HILL EAST PARCELS B1 + B2

WASHINGTON, DC
GTM ARCHITECTS DC PROJECT #21.0515

ZONING COMMISSION
District of Columbia
CASE NO. 24-008
EXHIBIT NO. 2A3

PARKING LEVEL 1 | A1.02

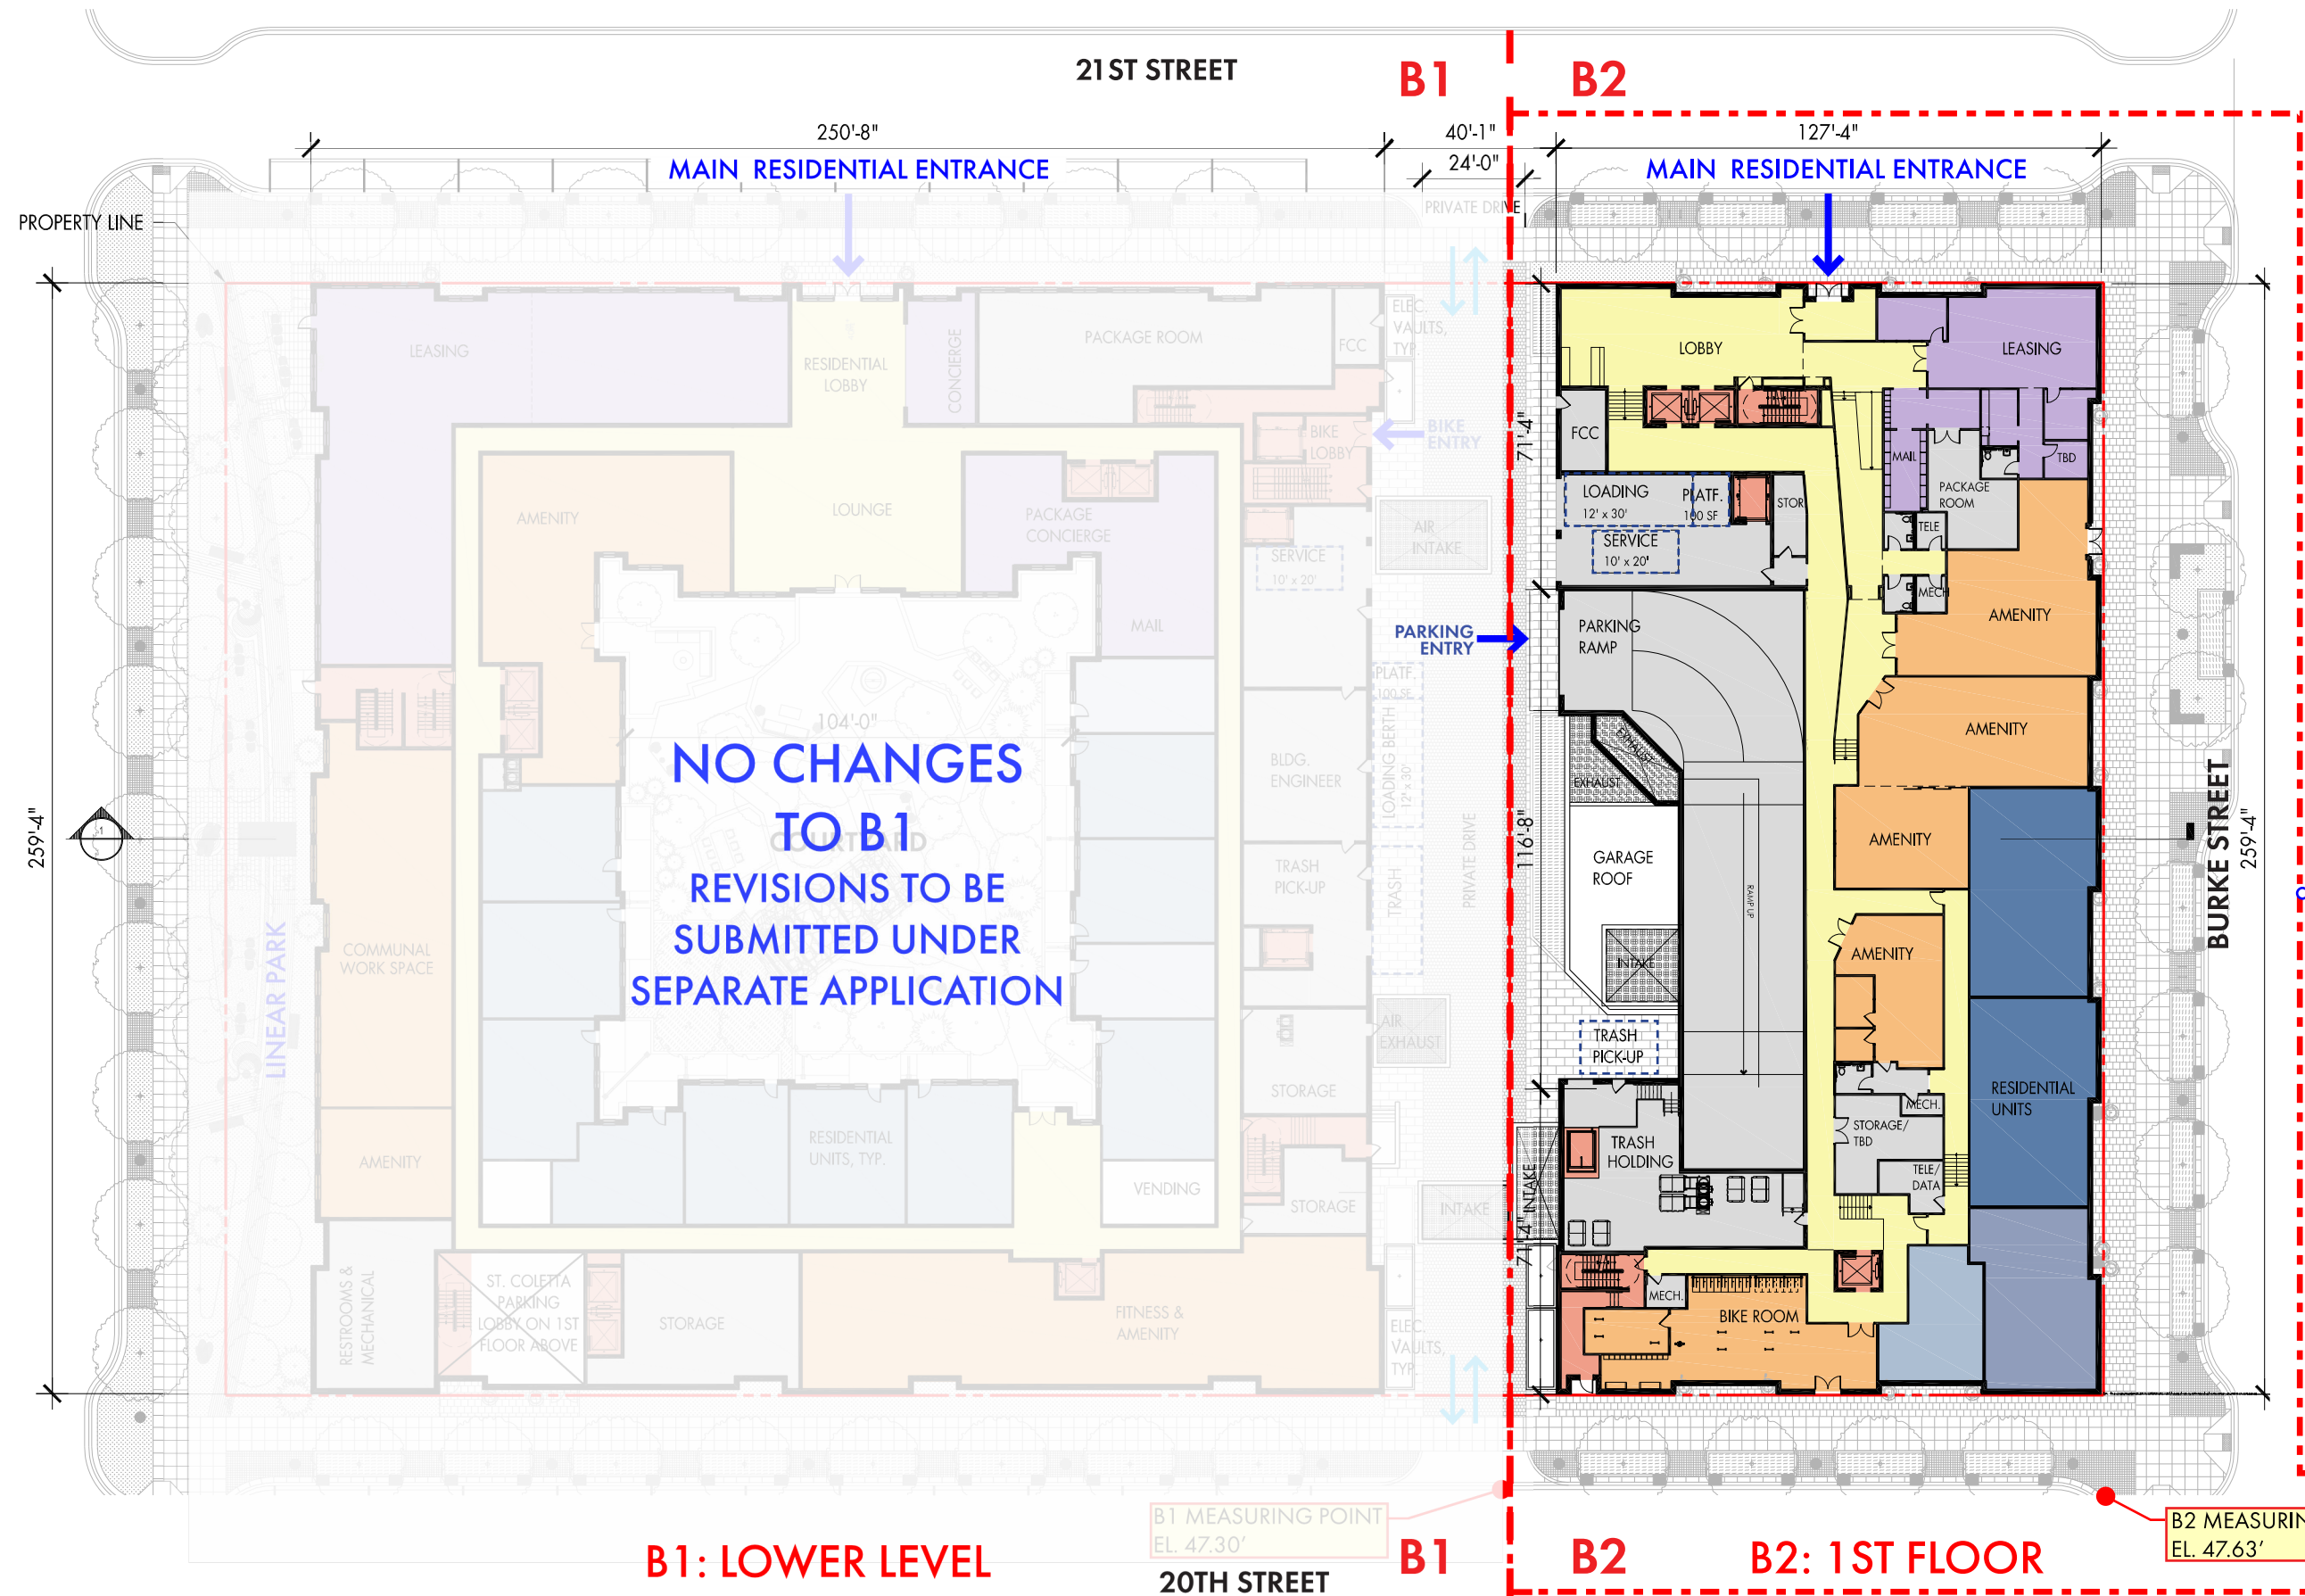
AREA OF MODIFICATION

NOTE:
VEHICLE AND BIKE PARKING REDUCED IN
BUILDING B2 DUE TO DELETION OF RETAIL AND
REDUCED UNIT COUNT.

FLOOR PLAN | A1.04

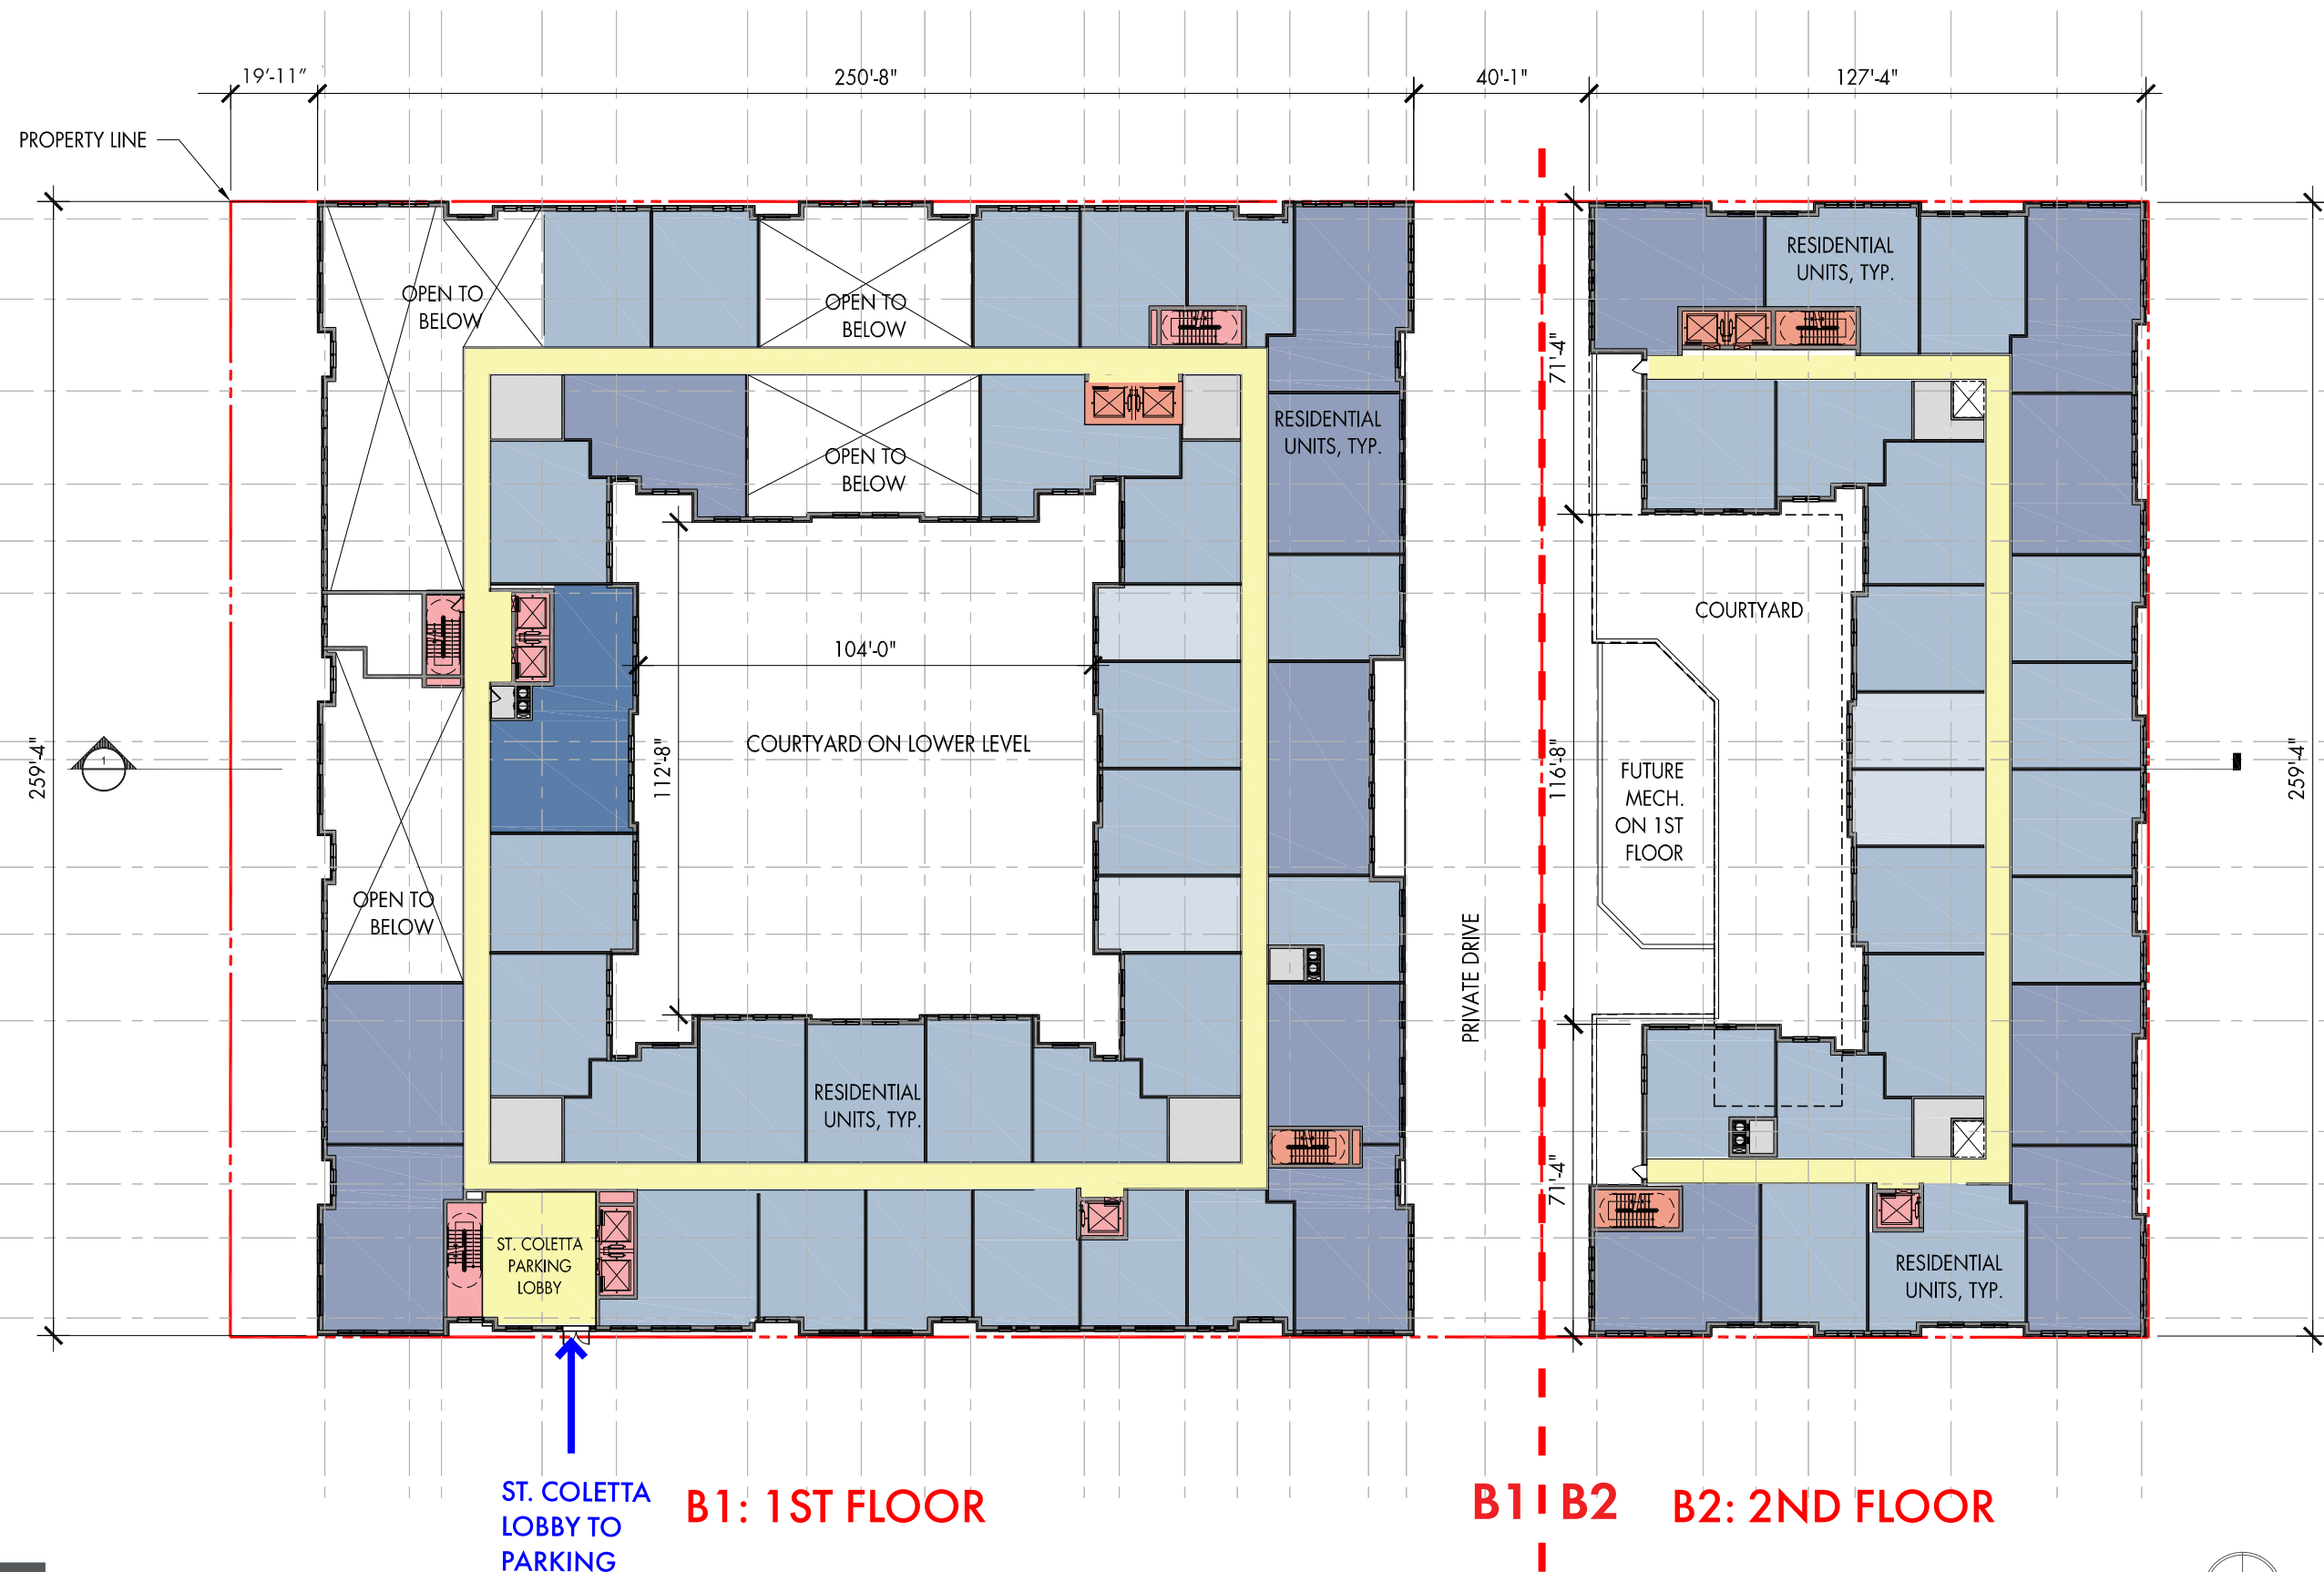
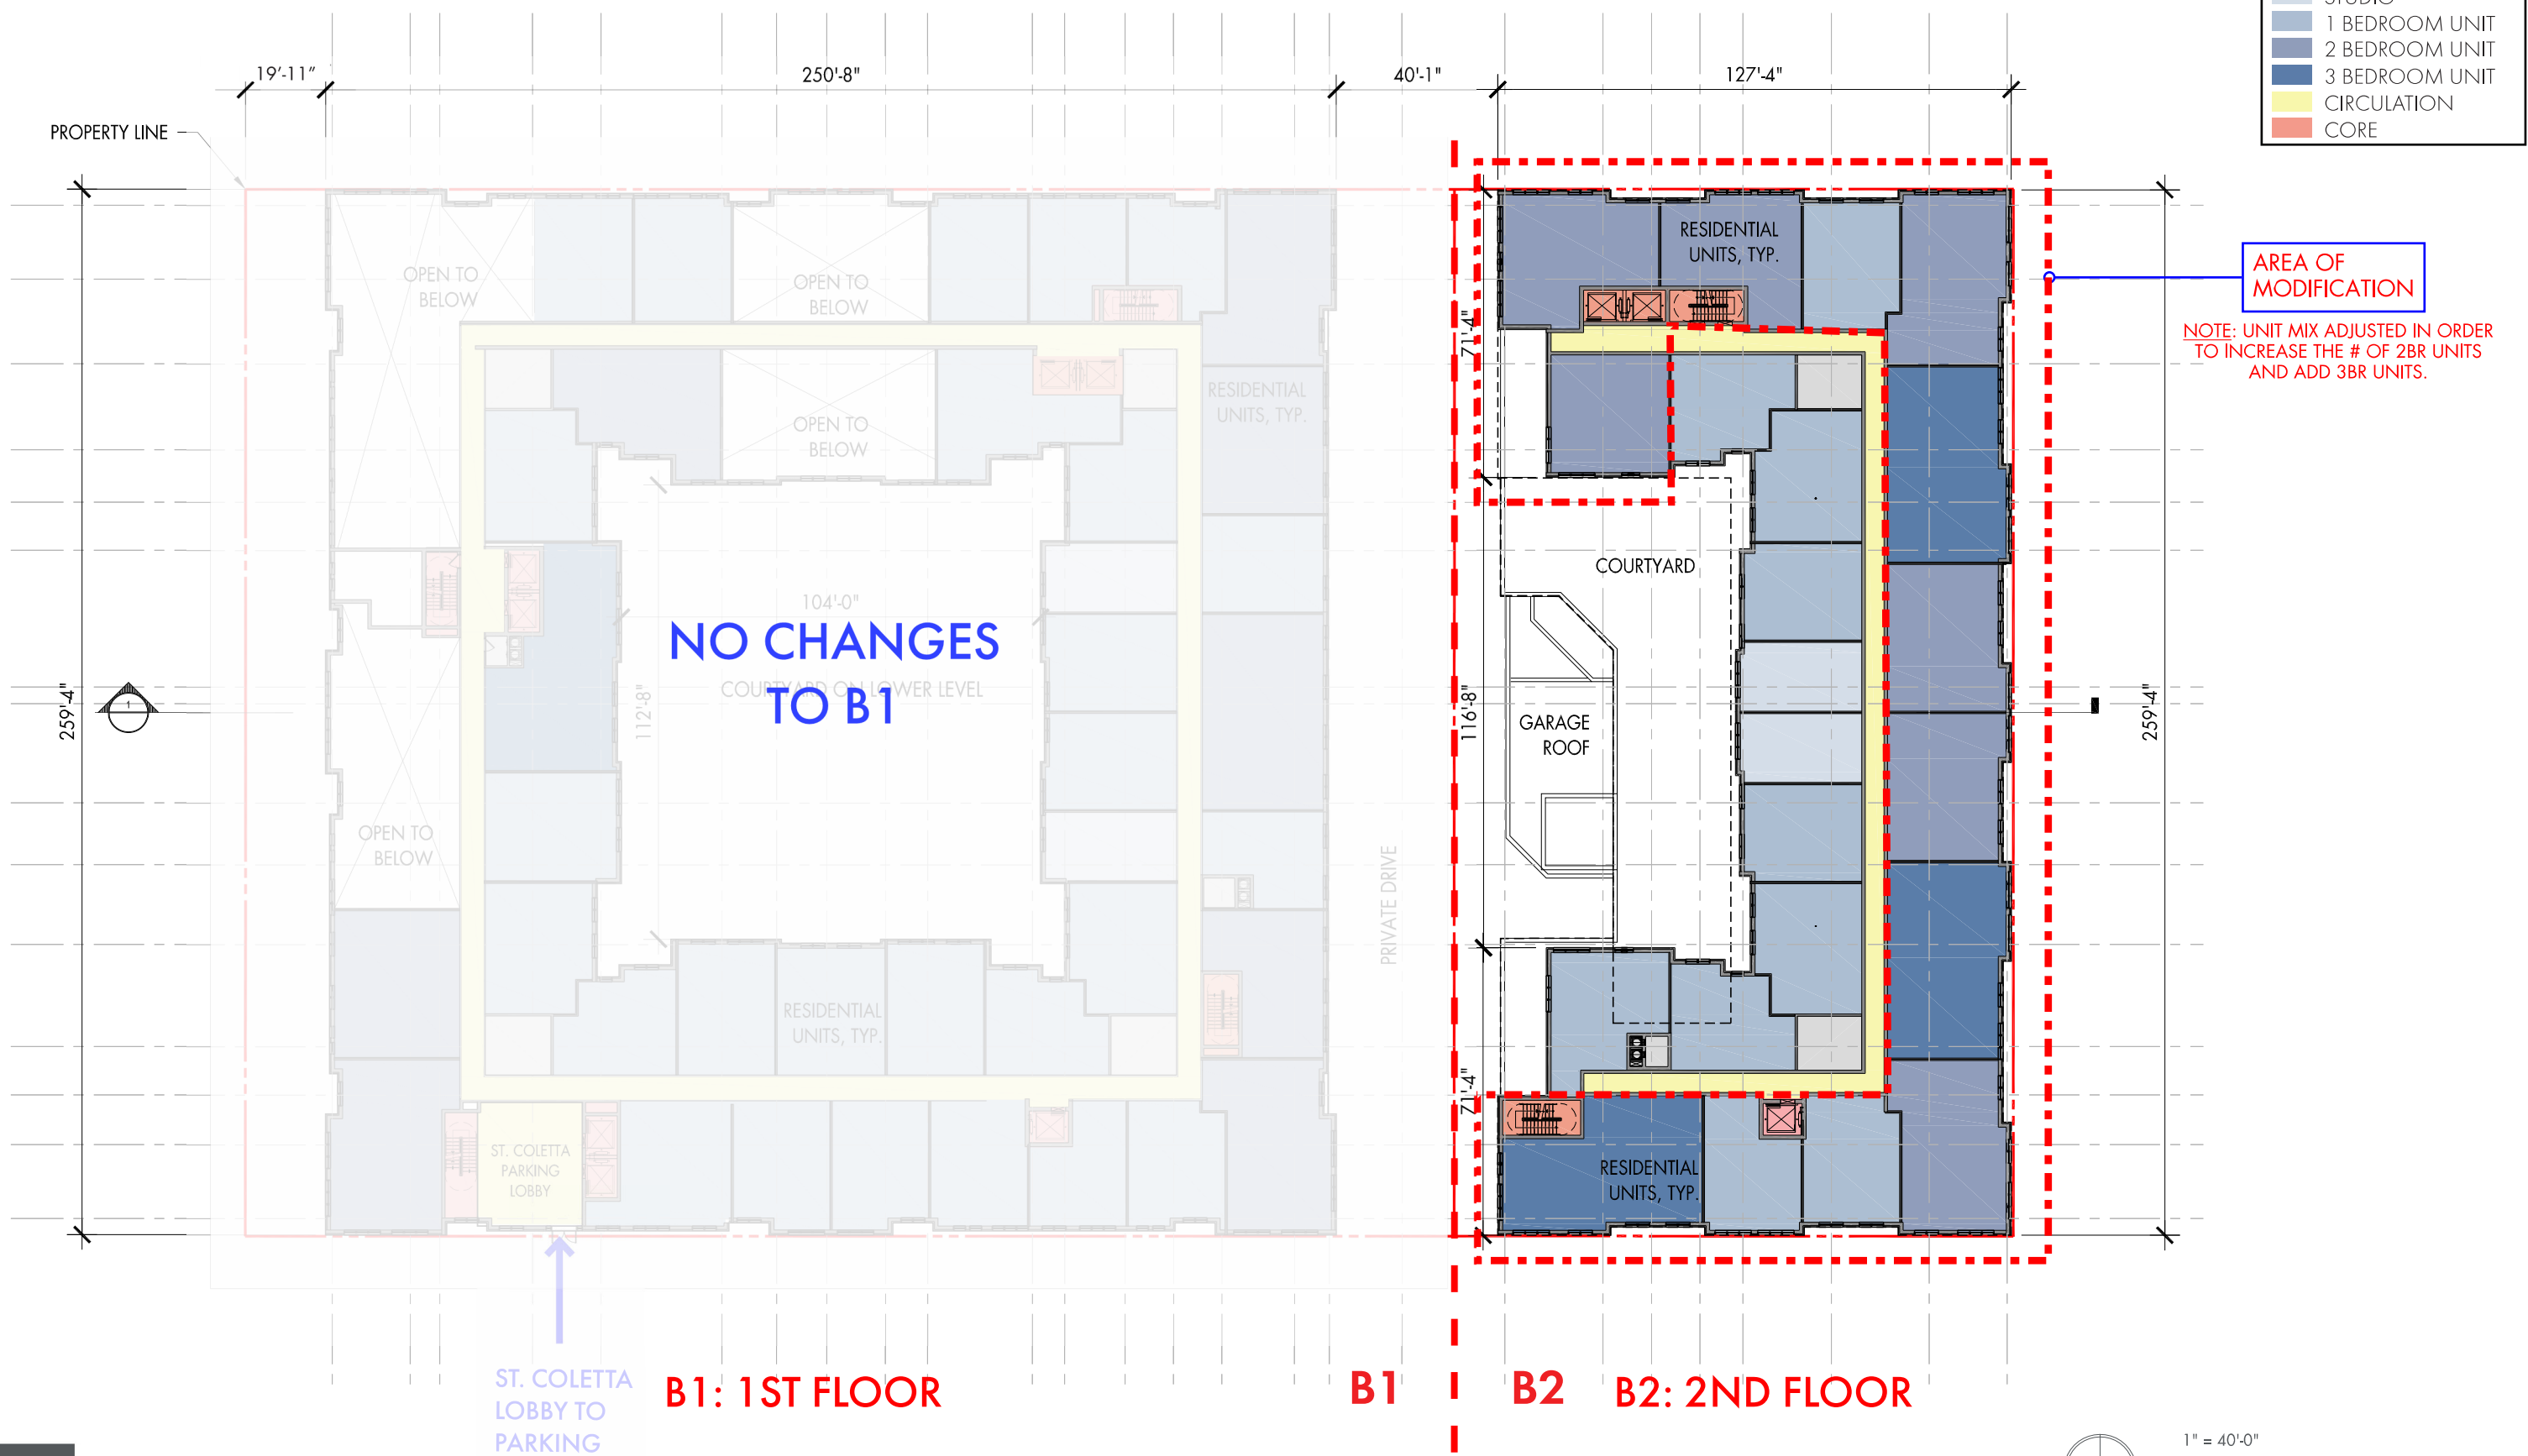
AREA OF MODIFICATION

NOTE: ADDED UNITS AND AMENITY SPACE DUE DELETION OF RETAIL SPACE.
